SI B51 19 16
Body Equipment

STEERING COLUMN STALK SWITCH STICKING

| i12 (i8) |

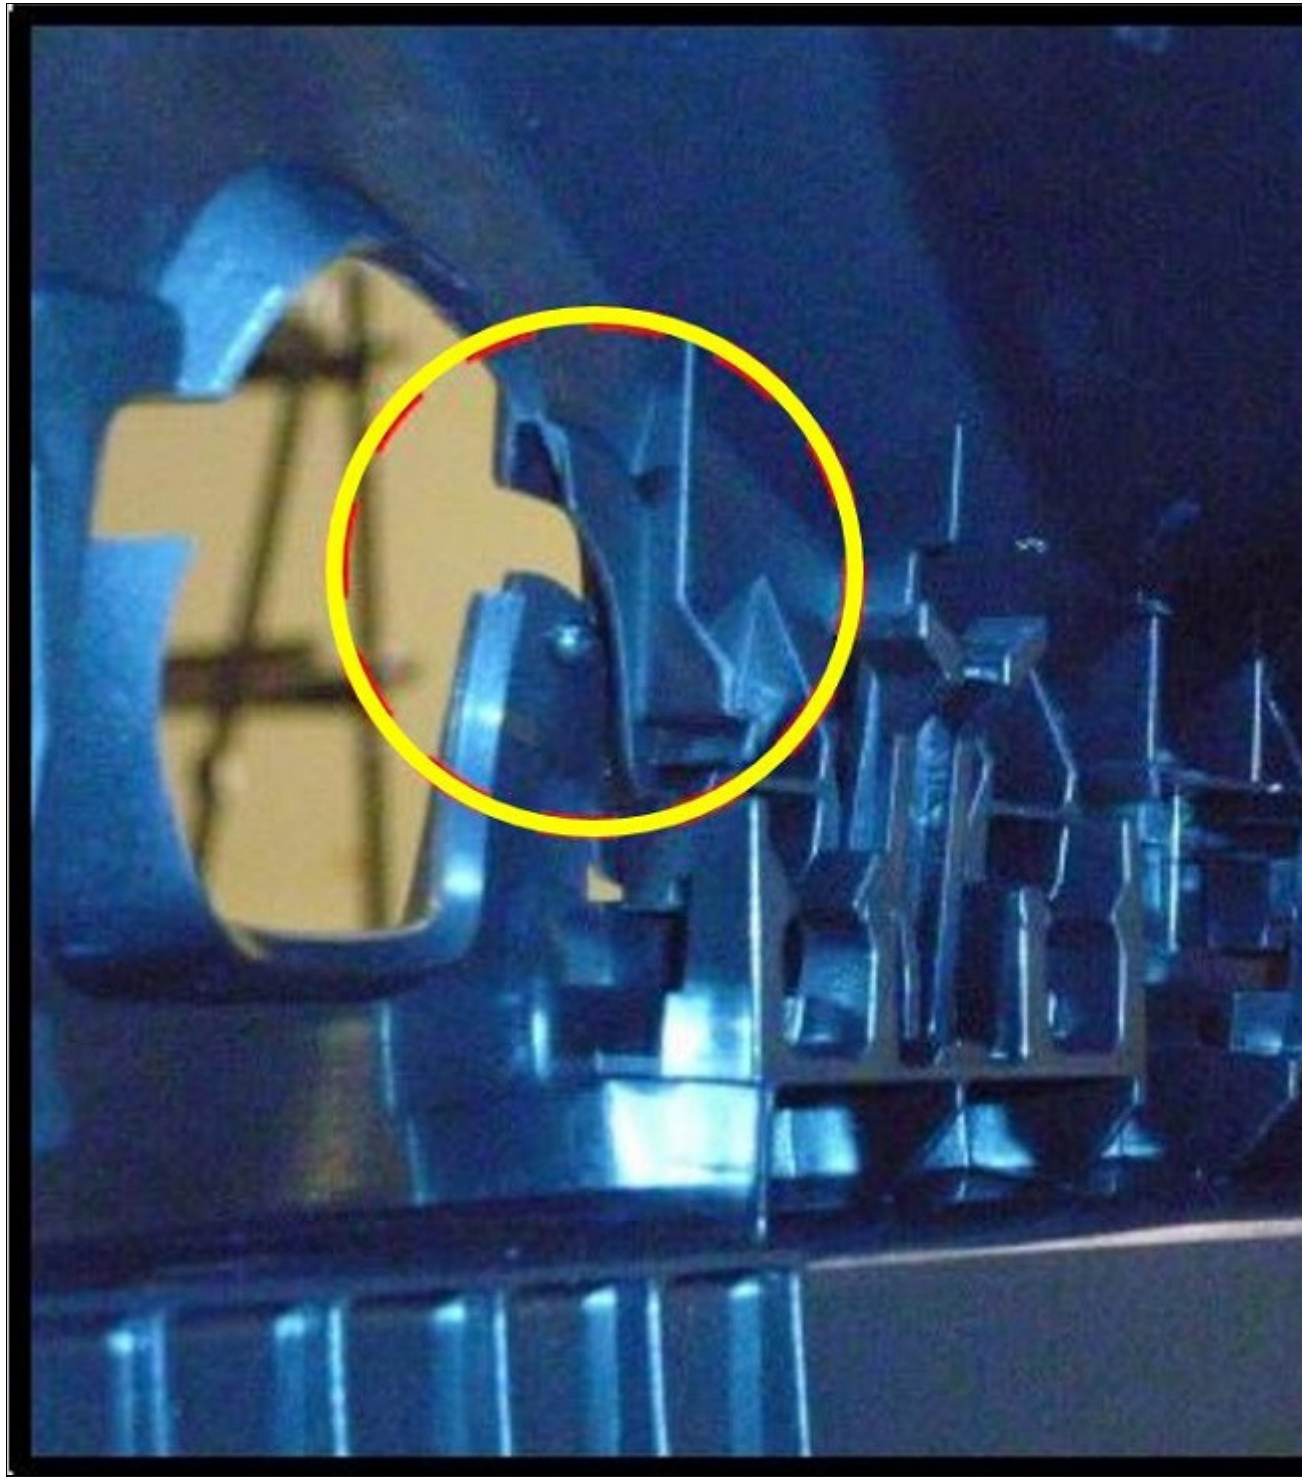
The steering column stalk switch for the turn signal sticks when actuating “headlight flasher” mode.

Interference fit between stalk switch and upper steering column shroud.

Modify steering column shroud.
